**Re: HPB 23-0574 -- Ritz/Sagamore Certificate of
Appropriateness Application for Properties
at 1 Lincoln Road and 1671 Collins Avenue.**

The owners/developers of the Ritz-Sagamore Project properties have applied for a Certificate of Appropriateness (COA) for renovations of the Sagamore Hotel, a one-story rooftop addition, porte-cochere and elevator at the Ritz Carlton Hotel, an elevated bridge between the two hotels, a 15-story residential tower to be situated behind the Sagamore Hotel, and site modifications. An application for a COA was submitted for a similar project in 2021. That application was not approved by the HPB.

*Figure 9. Proposed Site Plan for Ritz-Sagamore Project.
(Kobi Karp Architecture and Interior Design, Inc., Drawing A1.50, 5/8/2023)*

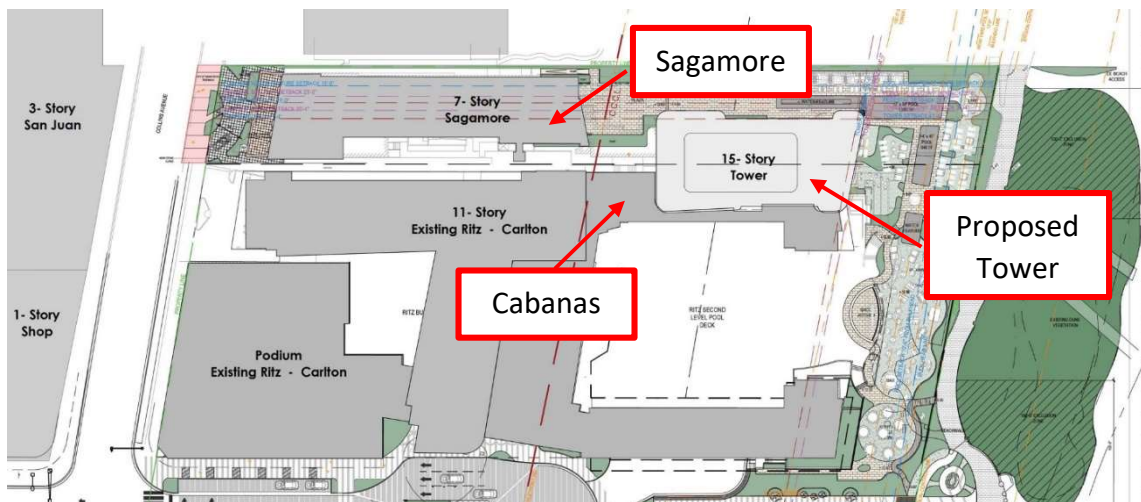
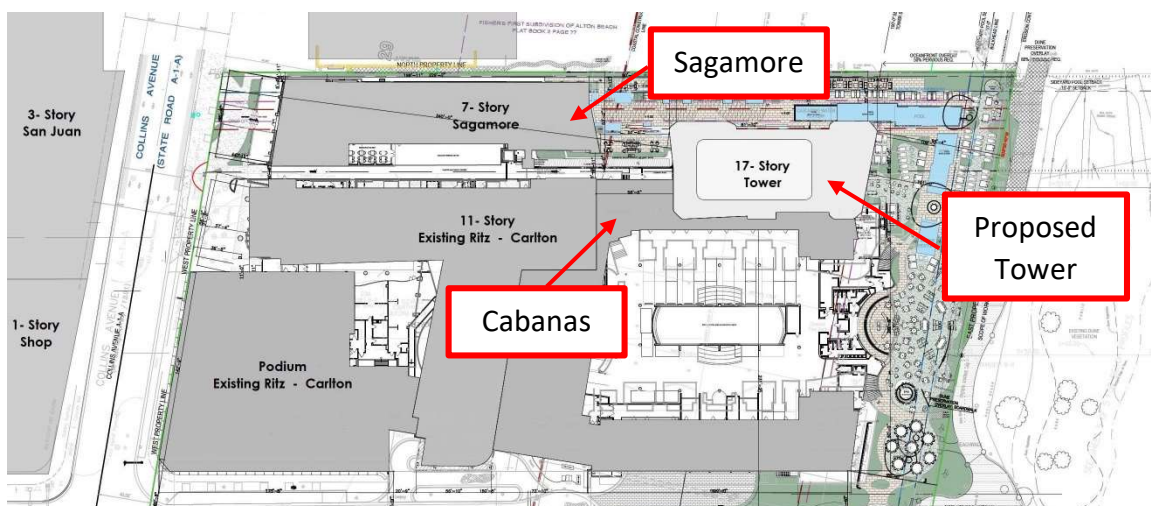
The Ritz-Sagamore Project proposes the construction of a 15-story, 182'-10" (202'-10" overall) tower behind the 7-story Sagamore Hotel. In 2019, the maximum building height for additions on lots of 115,000 square feet or greater was increased to 200 feet for RM-3 zoned oceanfront properties between 16th and 21st Streets. The subject properties, with combined lot sizes, meet the lot size criteria. The tower would be cantilevered over the cabanas located to the east of the Ritz-Carlton Hotel. (Figure 9)

The previous iteration of the project, from 2021, featured a 17-story, 200' tower (224'-0" overall) behind the Sagamore Hotel. The tower was to be cantilevered over the Ritz Carlton cabanas. (Figure 10)

*Figure 12. Proposed 2021 west elevation.
(Kobi Karp Architecture and Interior Design, Inc., Drawing A4.06, 11/12/2021)*

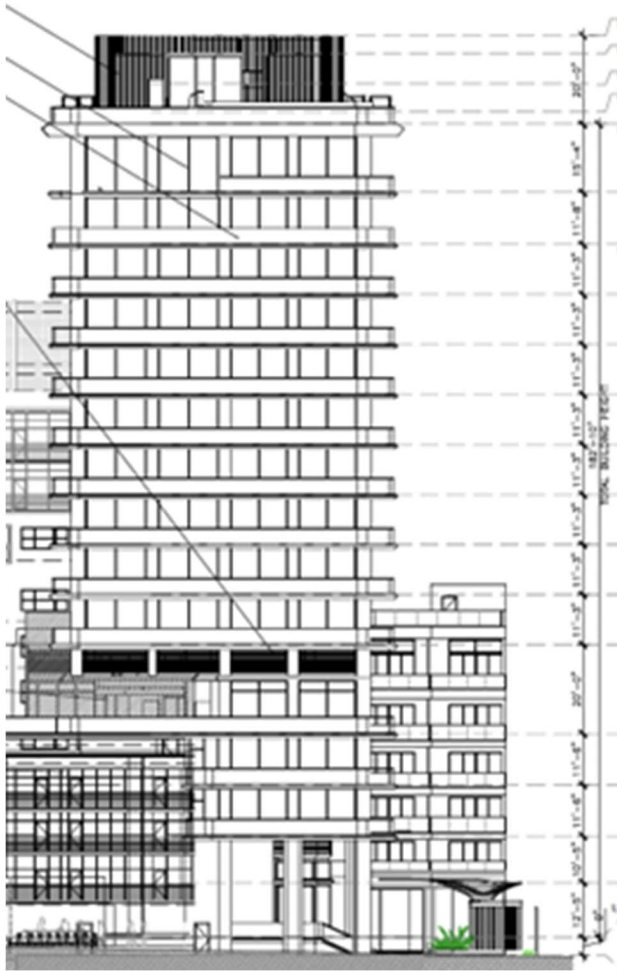
The proposed 182'-10" tower located behind the Sagamore Hotel would be out of scale with its surroundings and would dwarf the historic hotel (Figure 11), the same as the previous project. (Figure 12)

*Figure 14. East elevation of 2021 proposed tower.
(Kobi Karp Architecture and Interior Design, Inc.,
Drawing A4.04, 11/12/2021)*

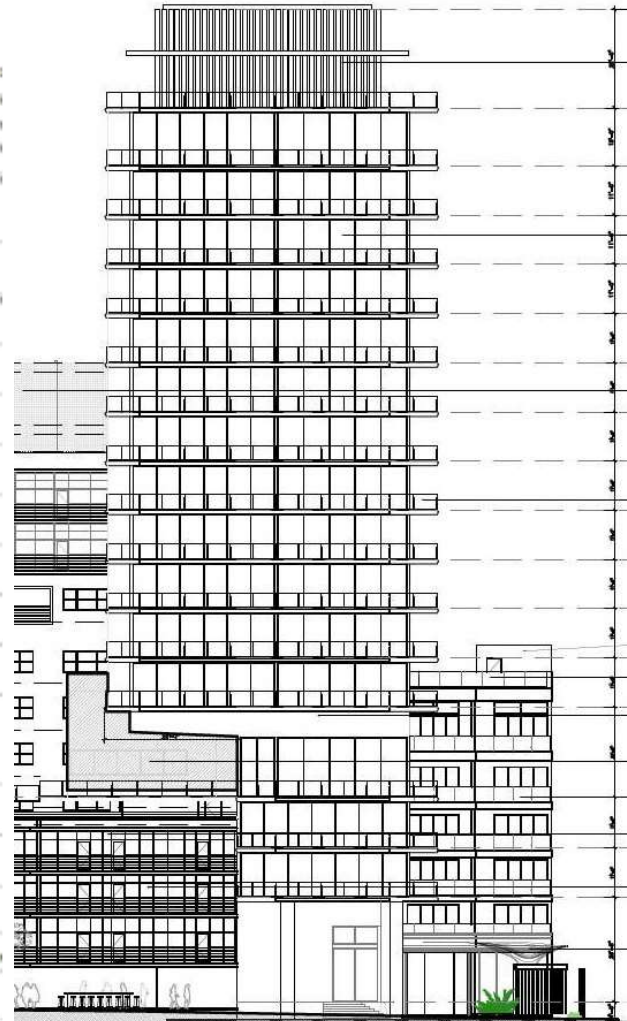
The overall height of the current proposed tower is 202'-10". The overall height of the tower in the 2021 proposal was 224'-0", a difference of 21'-2". (Figure 13, Figure 14)

The height to the top of the habitable space in the current proposed tower is 182'-10". The height to the top of the habitable space in the 2021 proposal was 200'-0", a difference of 17'-2".

Figure 47. Existing shadowing at Equinox, noon.
(Heritage Architectural Associates with K4 Architecture)

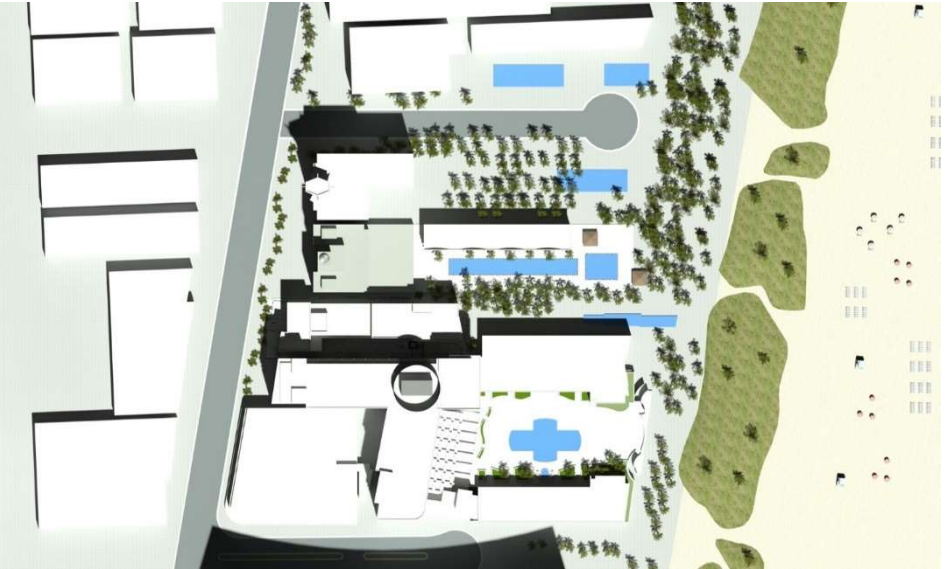
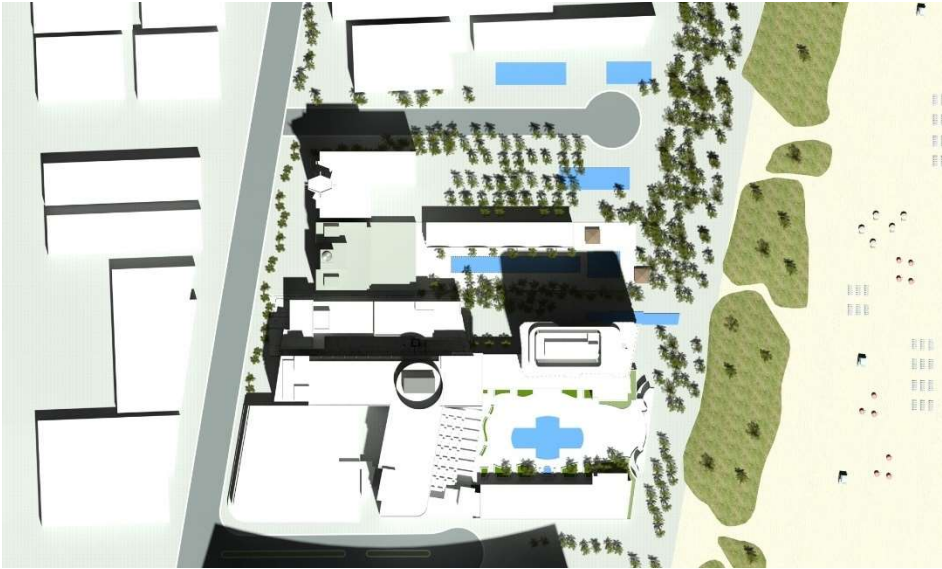
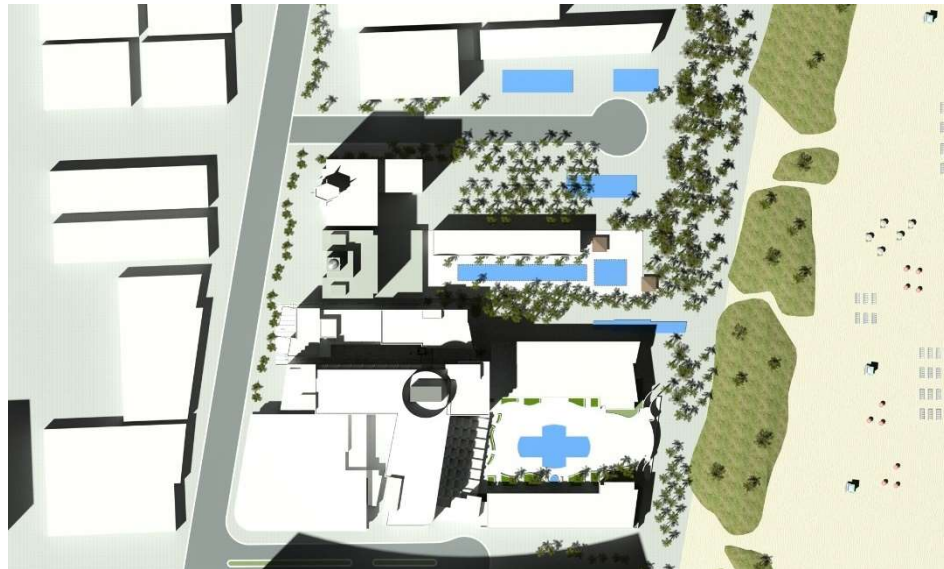
According to the solar shading studies shown, the addition of a 202’-10” building on the adjacent lot behind the Sagamore will have a significant impact on the National Hotel and will cast shadows on the pool area from approximately 10 a.m. until 3 p.m. during the Equinoxes, which was also the case with the 2021 proposed project. (Figure 44-Figure 55)

Figure 56. Existing shadowing at Winter Solstice, 10 a.m.
(Heritage Architectural Associates with K4 Architecture)

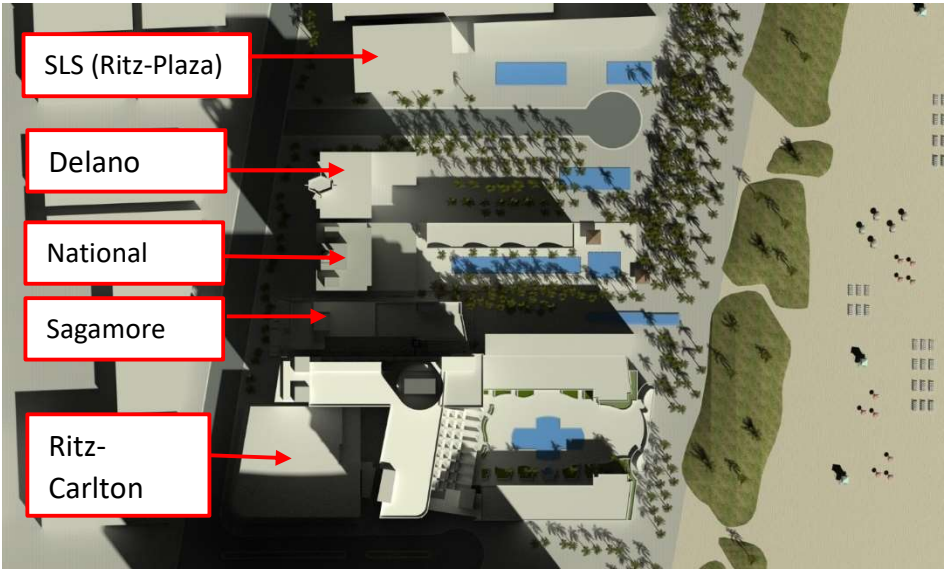
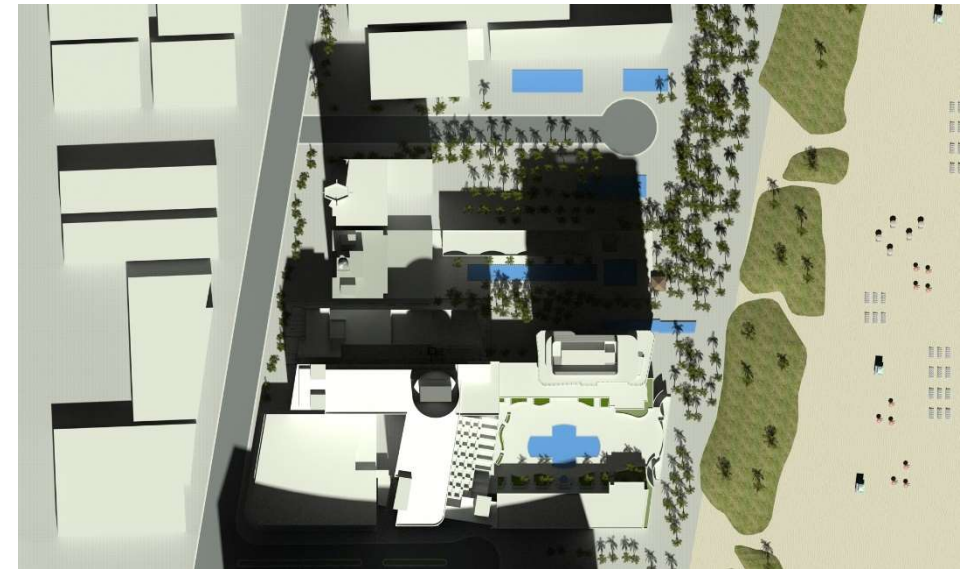
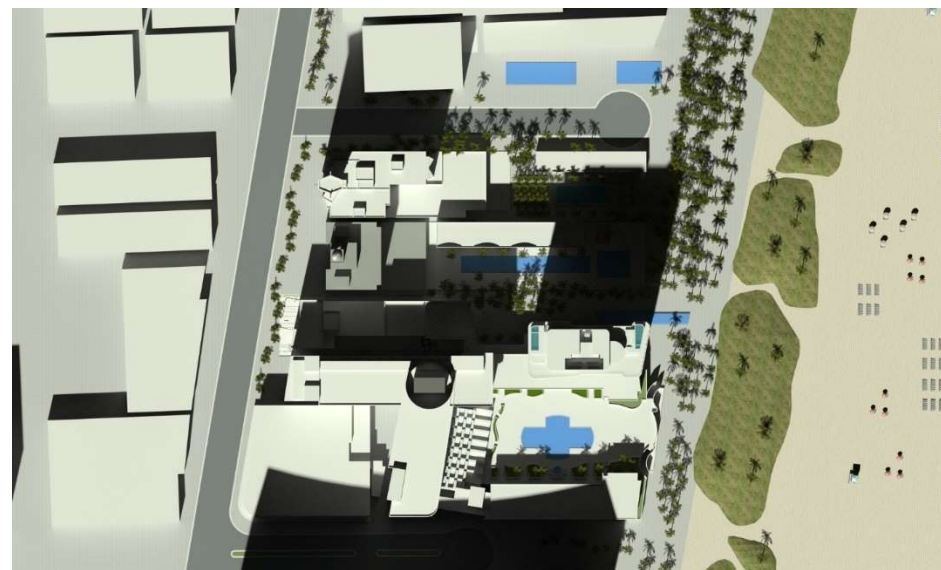
Significantly, the pool area at the National will be enveloped in shadows cast by a 202’-10” building during most of the day at the Winter Solstice, a time of year when occupants will be expecting sun in these light-inspired areas. The studies also show that the pool area at the Delano Hotel, two doors away from the Sagamore, will be in shadows cast by the 202’-10” tower from 11 a.m. after 2 p.m. during the Winter Solstice. (Figure 56-Figure 73) This was also the case with the 2021 proposed project.
